Technical Journal

Technical Journal Title New Volvo Car UX in Centre and Driver Display		Ref. No. TJ 37480.2.0	
Issuer (Dept.) Technical Service		Issue Date 2/19/26	Status Date 3/3/26
Car Market United States and Canada	Partner 3 US 7510 Volvo Car USA	Function Group 3900	
Function Description Media, navigation and communication		Page Page 1 of 4

TJ_37480_1.jpg

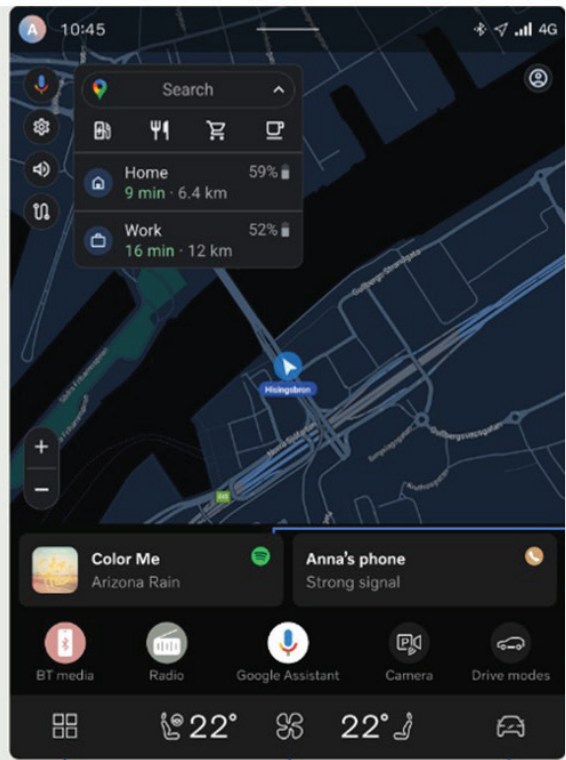
When the vehicle has 5.0.X software installed, it includes the new Volvo Car UX for both Centre Display and the Driver Display, see attachment TJ_37480_1. installing the update, follow advice under "Service".
